**BUILDING 700 (FORMERLY 330D)
CREPINI PHASE 2 EXPANSION
PRE-CONSTRUCTION SOIL SAMPLING AND
CAMP SUMMARY REPORT**

**IPARK 84
FORMER IBM EAST FISHKILL FACILITY
2070 STATE ROUTE 52
HOPEWELL JUNCTION, NEW YORK 12533**

FEBRUARY 2021

Re: iPark 84
Former IBM East Fishkill Facility
Building 700 (Formerly 330D)
Crepini Phase 2 Expansion Pre-Construction Soil
Sampling and CAMP Summary Report

DRAWING NO: P-101B
ISSUED 1/29/2021
REVISION NO: 0
24" x 36"

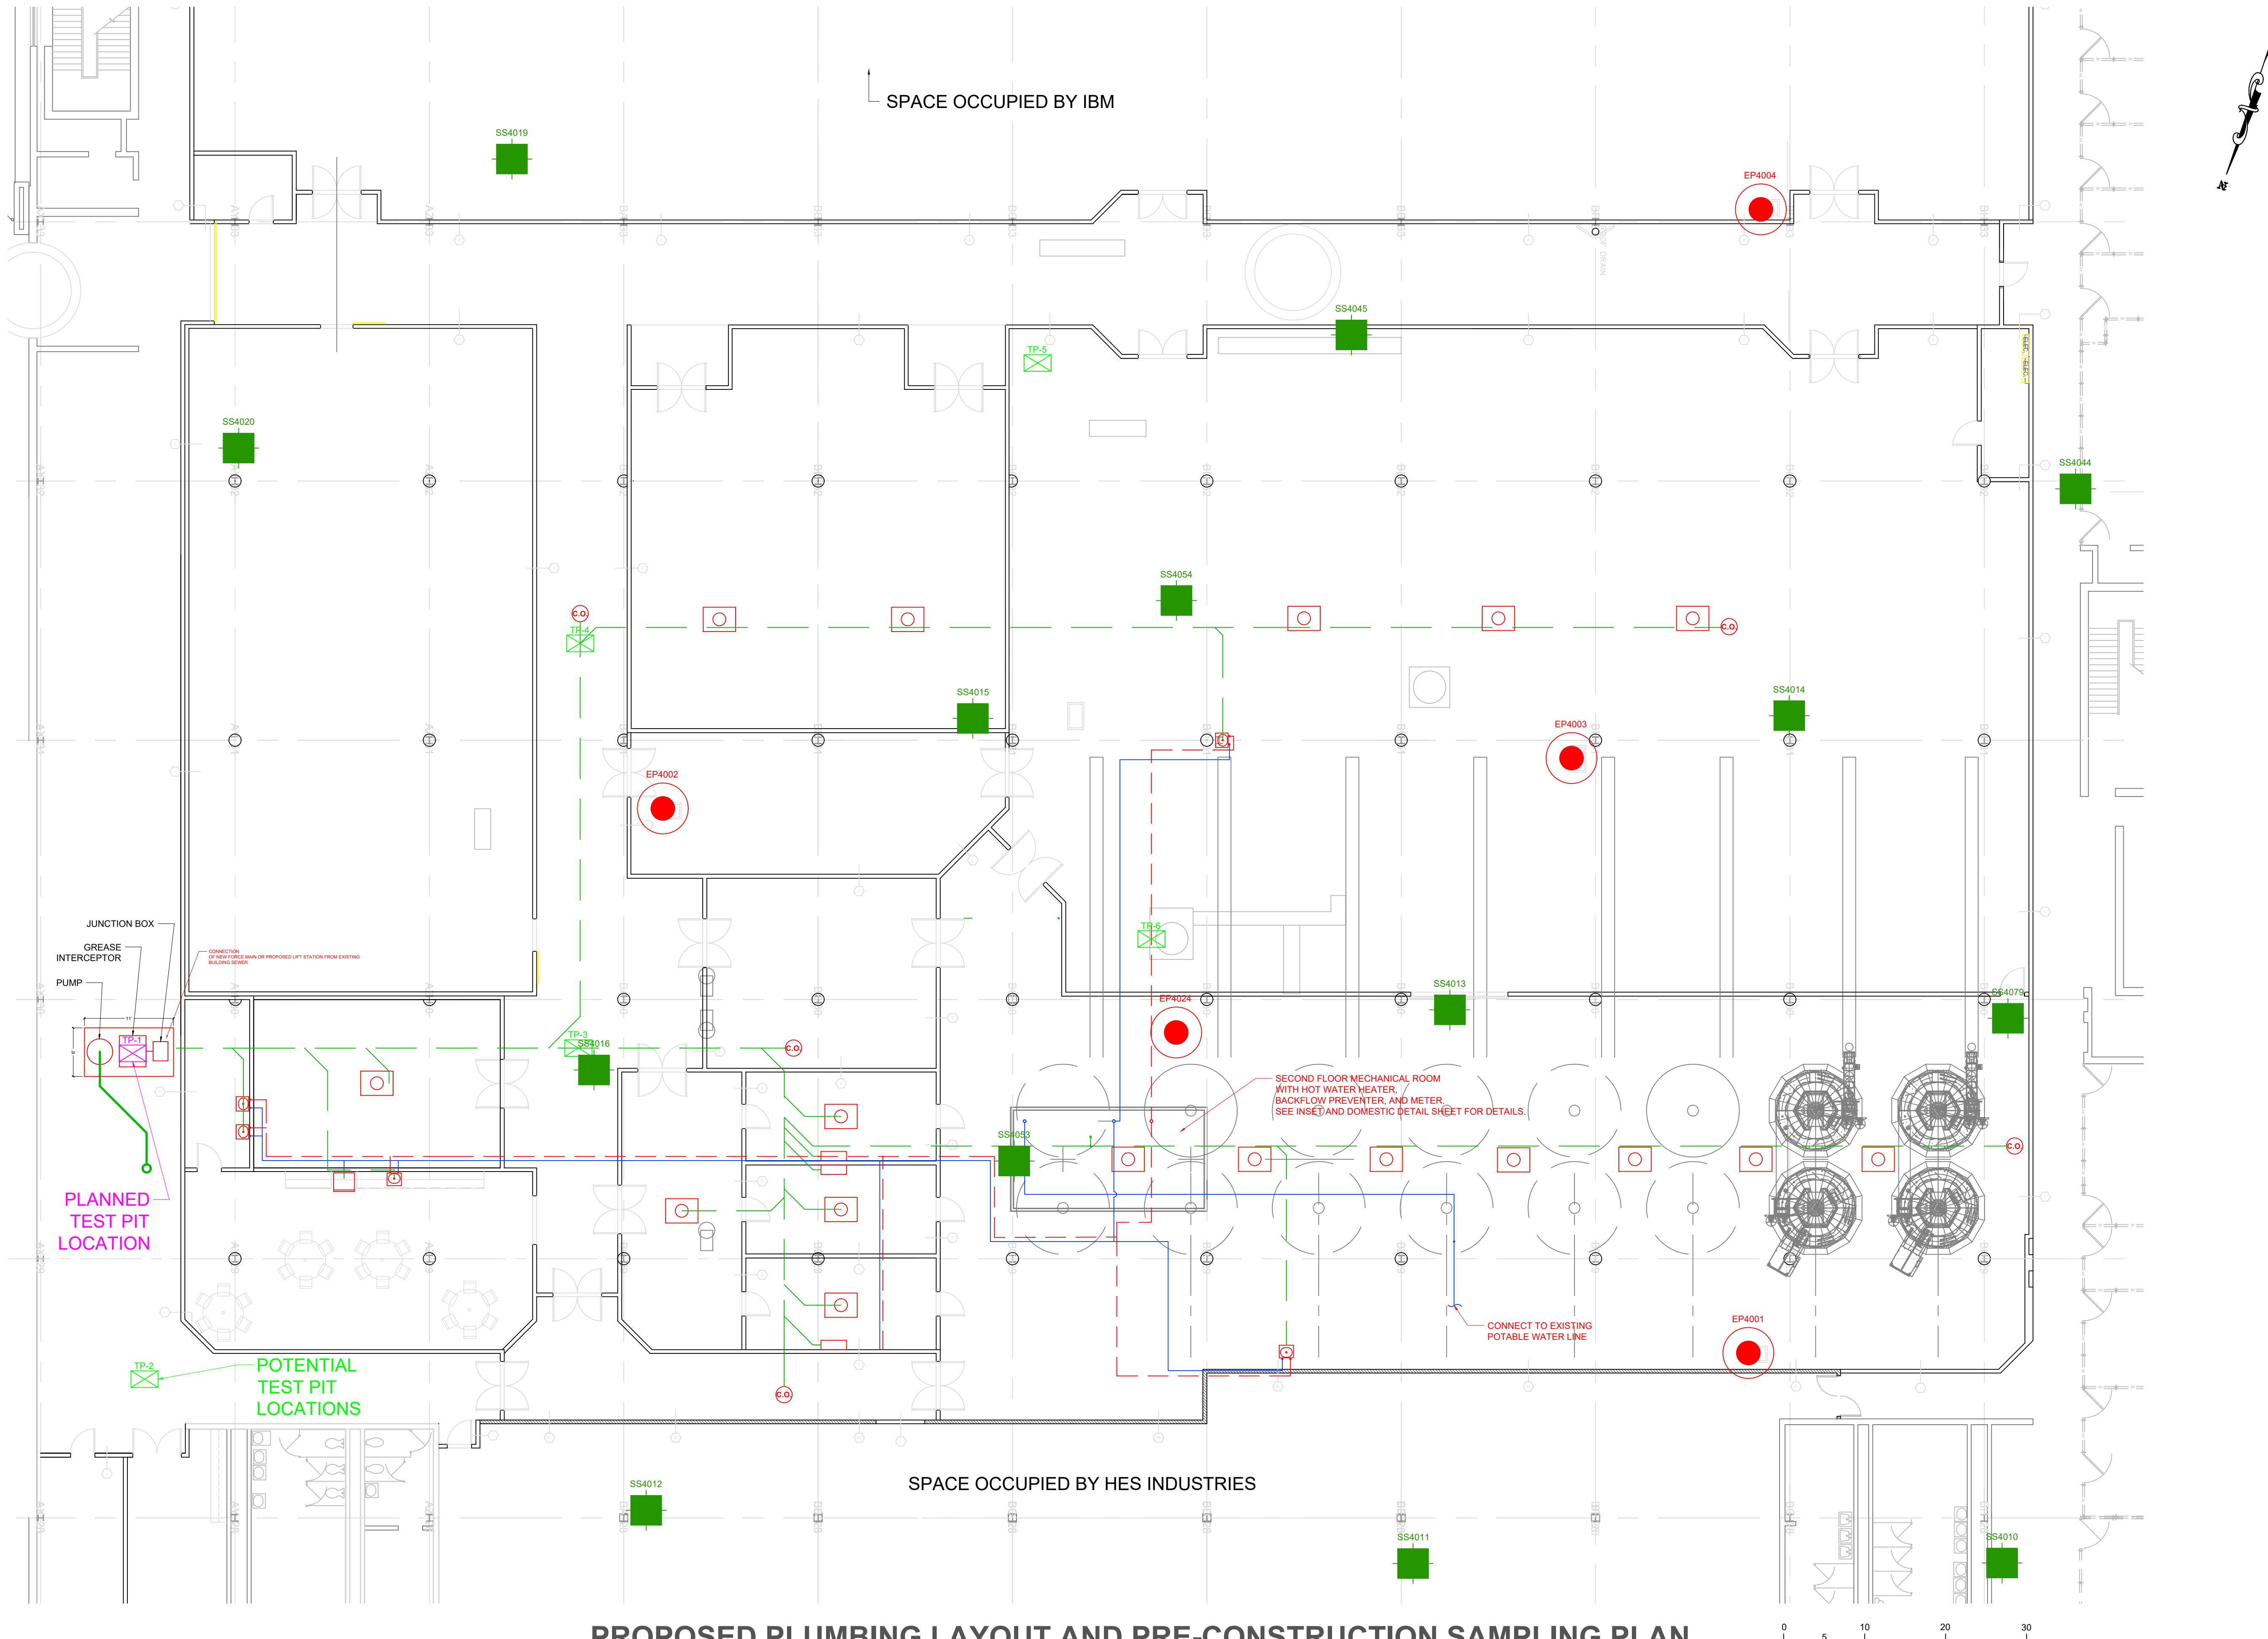
- Comment 1. The plumbing layout has been revised (see attached figure) and the proposed sanitary lift station is now located in the area of the lowest sub-slab VOC concentrations recorded beneath the Crepini Phase 2 expansion space. As discussed, sub-slab soil sampling will be performed in the area of the test pit (TP-1) to be excavated to evaluate the proposed lift station location. The attached figure shows five (5) potential alternate test pit excavation locations (TP-2 through TP-6) that may be excavated if the first location (TP-1) is determined to be unsuitable for the lift station.

5. Provide the Departments a figure that shows both the proposed plumbing layout and the current B330D Central SSDS piping.
6. Attachment B – Health and Safety Plan – The Departments will not be reviewing or approving the Health and Safety Plan. This does not have to accompany each workplan but should be referenced to notify people where it is located.

- Prior to cutting the slab and conducting the test pit activities, soil samples will be collected from one core placed in the middle of potential test pit excavation areas. Although six (6) locations are shown on the figure, we will focus sampling on the locations outside the VOC "hot" zone, only sampling in the higher VOC concentration areas if necessary. The decision on how many to evaluate/sample will be made in the field. We will inform DEC/DOH of the locations sampled on the day the drilling is performed.

- Comment 3. The State will be notified immediately in the event that Special Requirements CAMP air monitoring indicates that the organic vapor level is above twenty-five (25) ppm at the perimeter of the work area.
- Comment 4. Prior to conducting the pre-occupancy indoor air sampling, iPark will coordinate with IBM to ensure that the B330D Central SSDS is running properly in addition to the HVAC system.
- Comment 5. The attached figure shows the proposed plumbing layout, the current B330D Central SSDS extraction points and monitoring points (system piping is aboveground), and the proposed soil coring locations which correspond to the planned (TP-1) and potential test pit (TP-2 through TP-6) locations.
